Modular units for machine tool construction – Multi-spindle heads – Casing and input drive shaft dimensions

AMENDMENT 1

Amendment 1 to International Standard ISO 2912-1973 was developed by Technical Committee ISO/TC 39, *Machine-tools*. It was submitted directly to ISO Council, in accordance with clause 5.10.1 of Part 1 of the Directives for the technical work of ISO.

Figure 2 – Input drive shaft

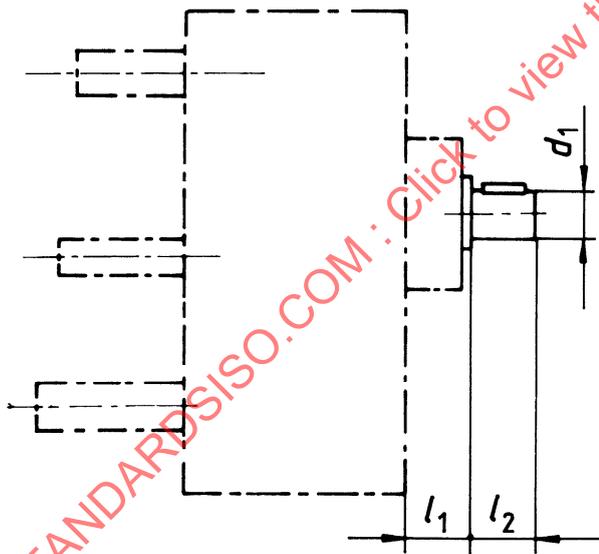
Figure 2; and table 2.

Delete the existing figure and table and substitute the following:

Table 2 – Dimensions of input drive shaft

d_1	tol.	l_1^*	l_2
28	j6	40	60
38	k6	50	70
42	k6	65	70
48	k6	80	85
60	m6	100	110
